VAYU HEIGHTS SUBDIVISION, RESUBDIVISION OF **LOT 23**

APPLICATION NUMBER 3 DATE April 16, 2020

REQUEST Subdivision

DETAIL SITE PLAN

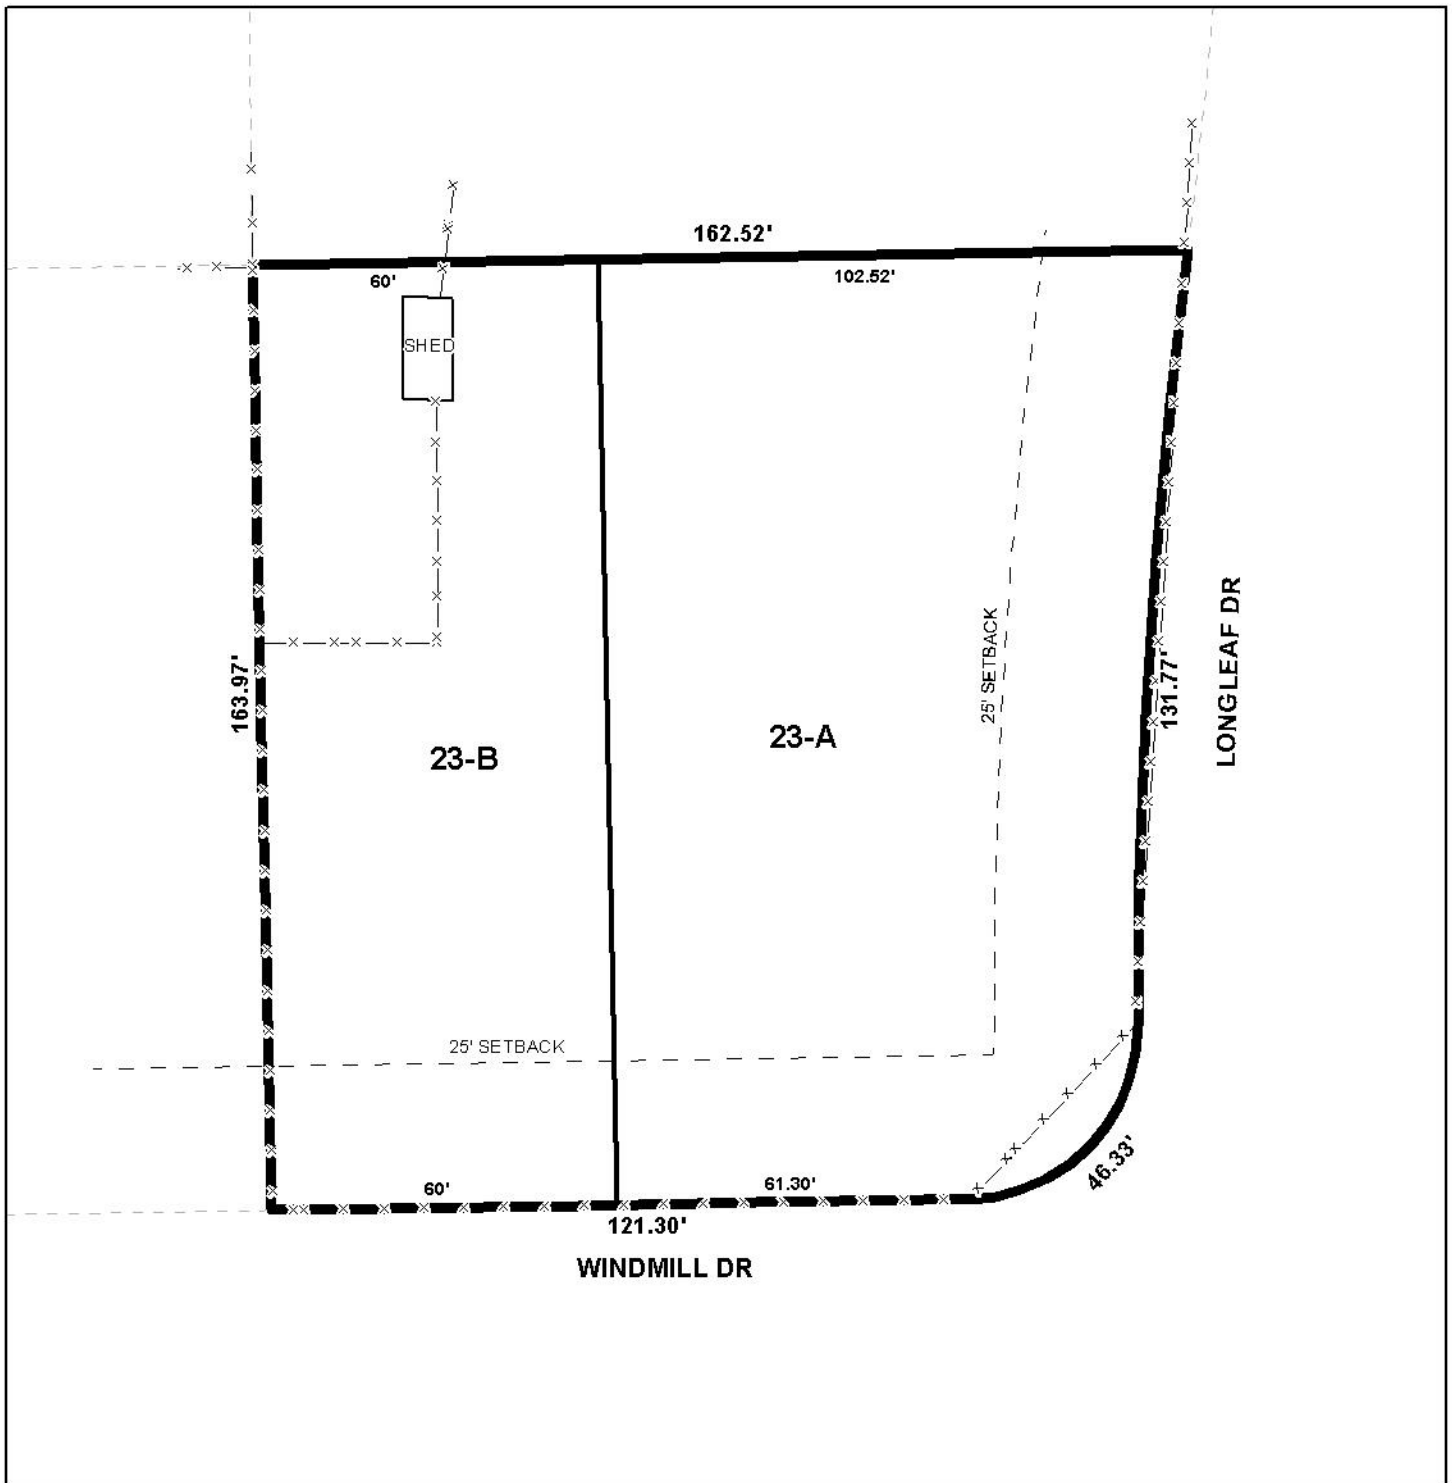
In accordance with the Subdivision Regulations, both proposed lots exceed the minimum dimensions and lot size requirements. If approved, the lot size labels in both square feet and acres should be retained on the Final Plat or a table should be furnished on the Final Plat providing the same information.

The lot was created as part of the Vayu Heights Subdivision, recorded in 1953. As proposed, Lot 23-A has frontage on both Longleaf Drive and Windmill Drive and Lot 23-B fronts Windmill Drive only. Both Longleaf Drive and Windmill Drive are minor streets with curb and gutters each requiring a 50-foot right-of-way width. The preliminary plat does not illustrate a right-of-way width for either street, however, the original plat from 1953 depicts either the presence of or the dedication to provide sufficient right-of-way for each street. As such, if approved, the Final Plat should be revised to illustrate the right-of-way width for both Longleaf Drive and Windmill Drive.

The preliminary plat illustrates compliant 25-foot minimum building setbacks along all frontages and should be retained on the Final Plat. As a means of access management, a note containing the Traffic Engineering comments should be placed on the Final Plat.

- 1) revision of the Final Plat to illustrate the right-of-way width for both Longleaf Drive and Windmill Drive;
- 2) retention of the lot size labels in both square feet and acres on the Final Plat or the furnishing of a table on the Final Plat providing the same information;

- 4) *placement of a note on the Final Plat stating the Traffic Engineering comments: (Each lot is limited to one curb cut per street frontage. Size, location and design of curb cuts to be approved by Traffic Engineering and conform to AASHTO standards.);*
